Regional Review Finding

Development of Regional Impact

RE: Development of Regional Impact (DRI) Review

Name of Proposal: Dekalb Concrete Plant DRI 4378

SITE PLAN
GRTA DRI # 4378

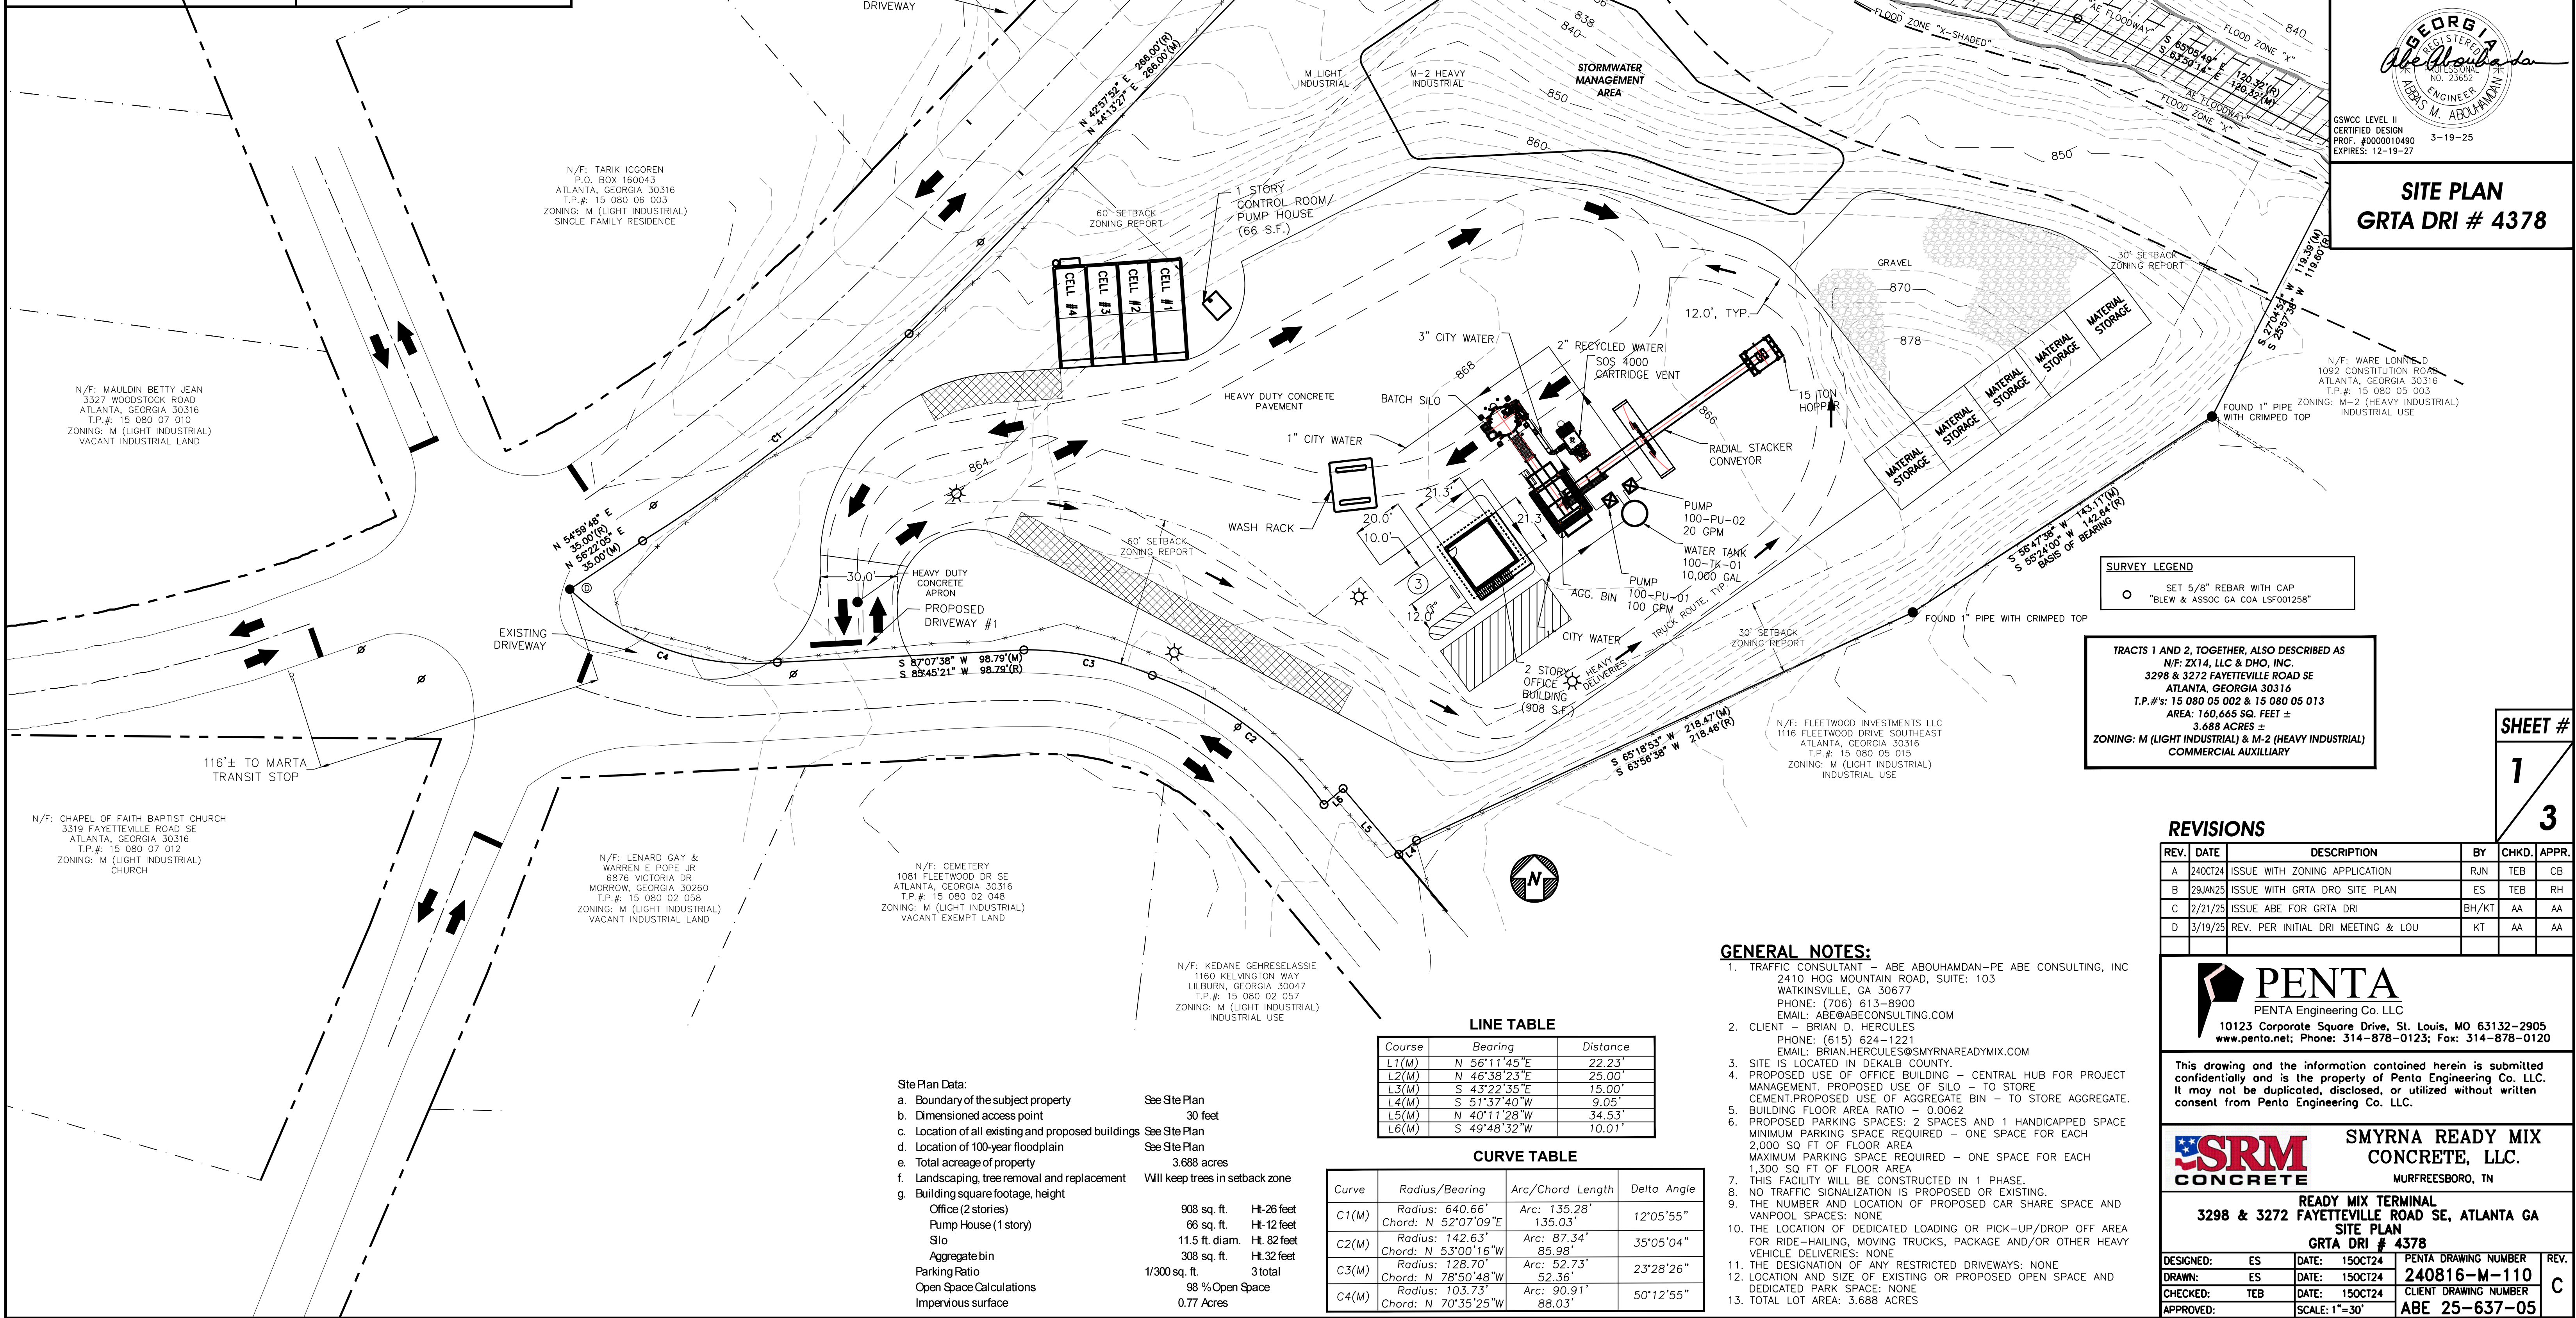
Stream buffers are shown on the plan as measured from the wrested vegetation lining the stream. Dekalb County regulations actually state that "Stream buffers shall consist of the contiguous undisturbed natural vegetative land a minimum of seventy-five (75) feet from each stream bank measured horizontally on both banks of the stream from the top of the stream bank." The buffer shown on the plans should be revised accordingly and the note revised to reflect the correct starting point of the buffer. No proposed development is shown within the stream buffers as mapped, but if the revision of the County buffer results in any intrusions into the buffer, variances may be required.

The existing buffer of natural space with trees along the edges of the site should be retained to the greatest extent possible.

The proposal is largely consistent with ARC's Metropolitan Transportation Plan. Bike and pedestrian connections are proposed between the site and bus stops, which enhances access to the site. Proposed development will increase truck traffic and decrease tree coverage but is consistent with surrounding uses.

An unnamed tributary to Entrenchment Creek forms the northeastern boundary of the project property, as shown on the project site plan. Both the USGS coverage for the project area and the submitted site plan show the tributary as a blue-line stream. Both the 25-foot State Sediment and Erosion buffer and the County 75-foot stream buffer are shown and identified along the stream. However, the plan notes that the 75-foot County buffer is measured from the "wrested vegetation", but the County ordinance, Sec. 14-44.1. - Land development requirements and allowable stream buffer encroachments, states that "Stream buffers shall consist of the contiguous undisturbed natural vegetative land a minimum of seventy-five (75) feet from each stream bank measured horizontally on both banks of the stream from the top of the stream bank" (underlining added). The buffer shown on the plans should be revised accordingly and the note revised to reflect the correct starting point of the buffer. No proposed development is shown within the stream buffers as mapped, but if the revision of the County buffer results in any intrusions into the buffer, variances may be required.

The FEMA coverage for the project area shows both the 100 -year floodplain (Zone AE) and the 500-year floodplain (Zone X) along the unnamed blue-line stream, as well as the stream's floodway. The FEMA floodplains and floodway are shown on the proposed site plan and no intrusions into the floodplains are shown on the plans
